RE: REVISED DRAINAGE PLAN FOR VIETNAMESE BUDDHISTS CONGREGATION
(K18-D69) REVISION DATED 4/8/97

DRAINAGE INFORMATION SHEET

DRAINAGE AND GRADING PLAN FOR PROPOSED MEETING HALL

DRAINAGE PLAN

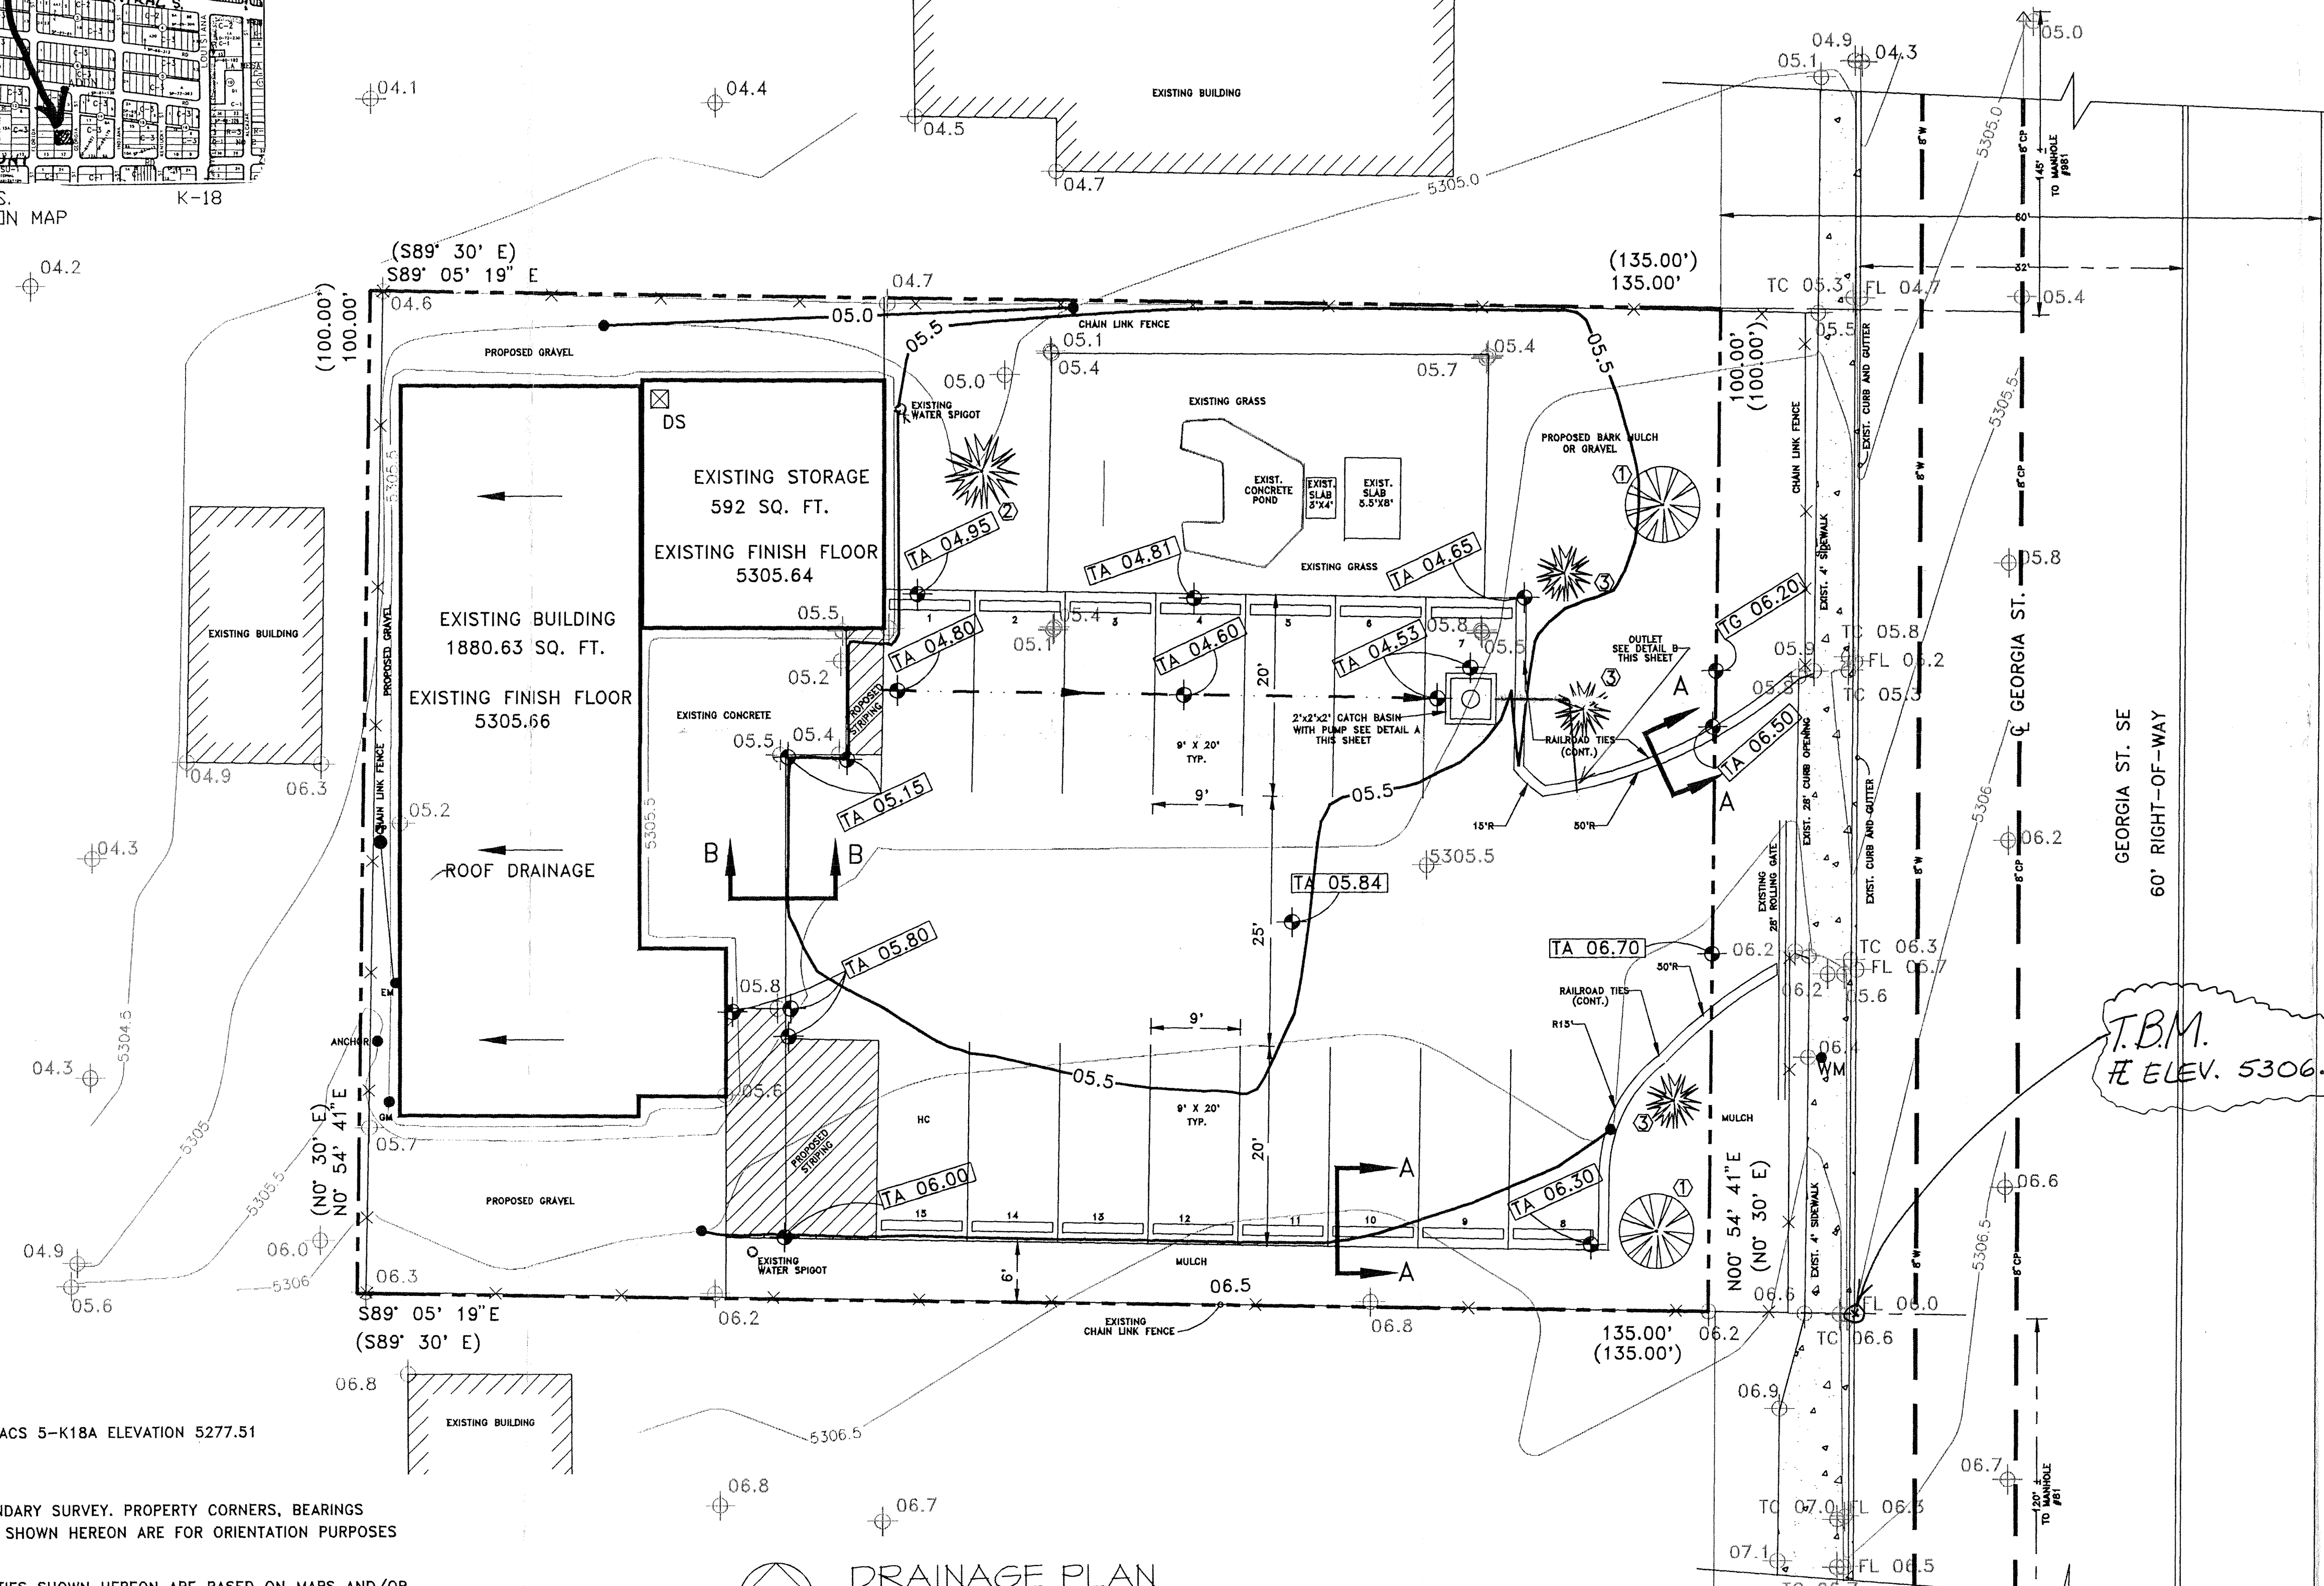
Based on the information provided on your April 8, 1997 resubmittal, the above referenced site is approved for Grading/Paving.

Please attach a copy of this approved plan to the construction sets prior to sign-off by Hydrology.

Also, after construction is completed, Engineer Certification per the DPM checklist will be required.
